Infrastructure Feasibility Study

Arizona State Land Department

Union Pacific Railroad

Planning and Engineering Study

EXHIBIT TITLE: INFRASTRUCTURE ASSESSMENT
SURROUNDING INDUSTRIAL DEVELOPMENT
PROPOSED DRAINAGE - INDUSTRIAL DEVELOPMENT

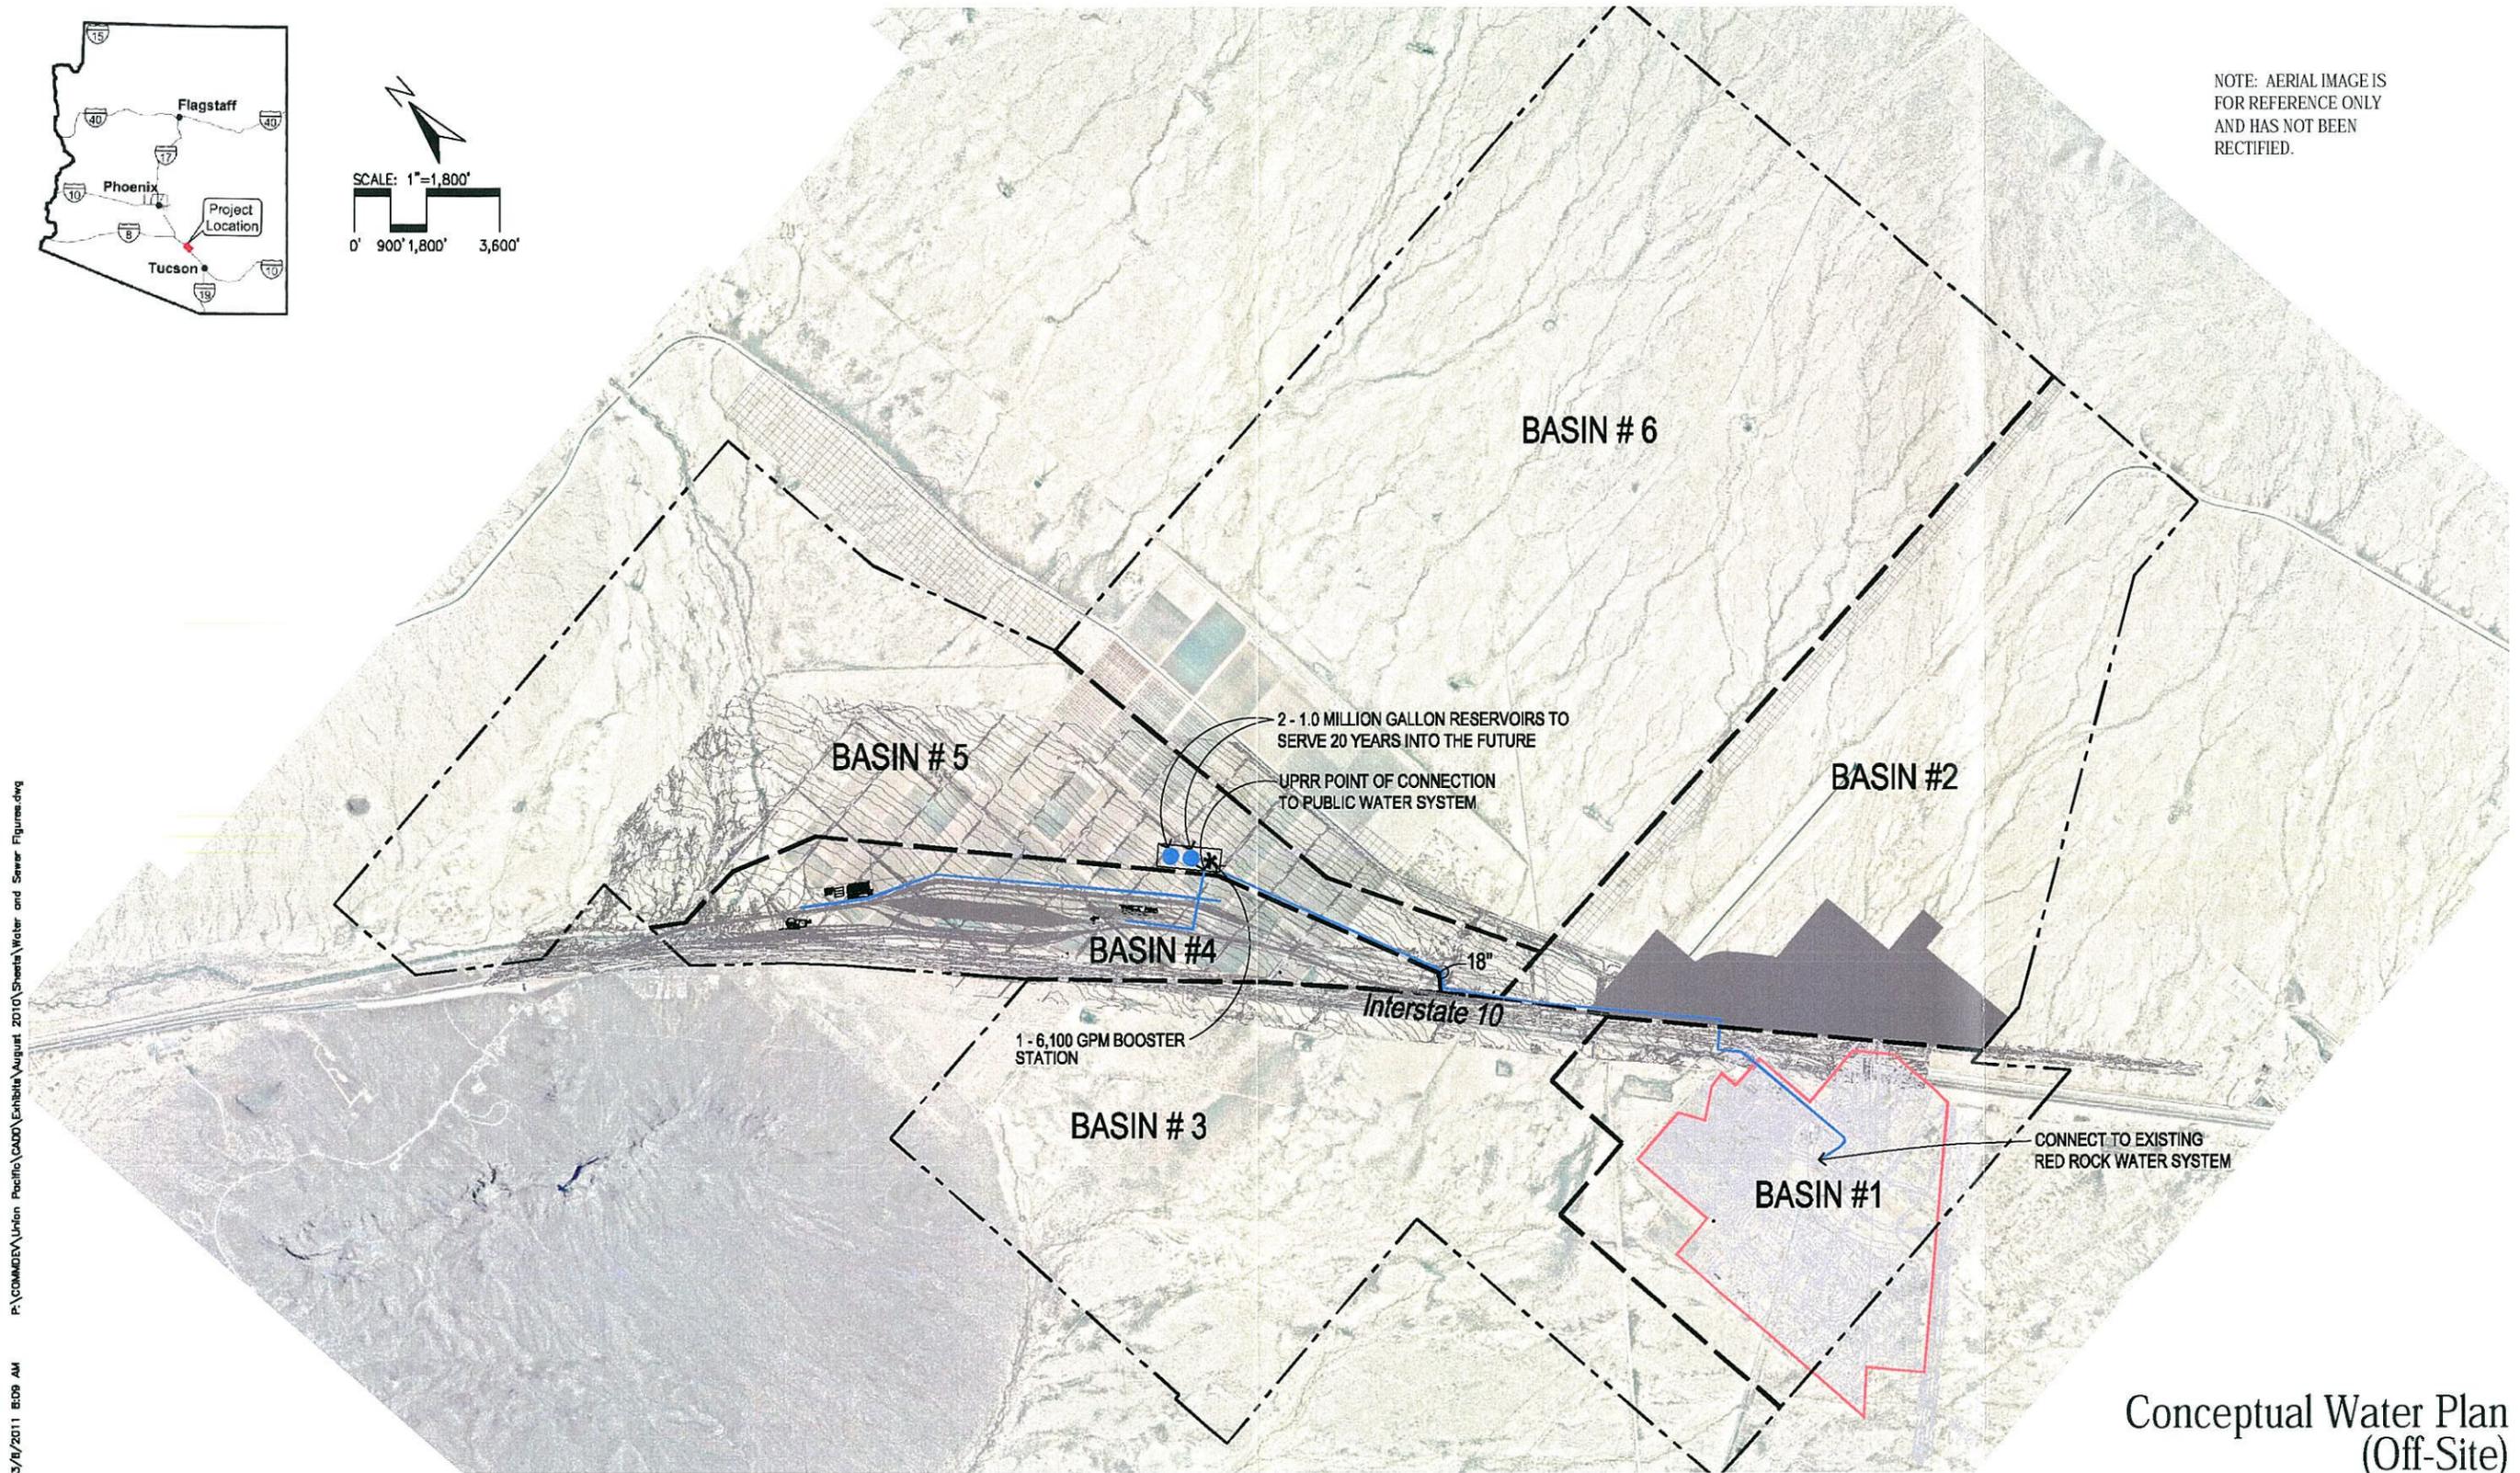
potential industrial park develops, the interceptor and detention basin would not be necessary so it could potentially be converted to provide retention for the 1,200 acre potential industrial park. This solution requires the construction of levees to provide 100-year protection. Refer to Exhibit 13, which shows the Parker Wash proposed solution.
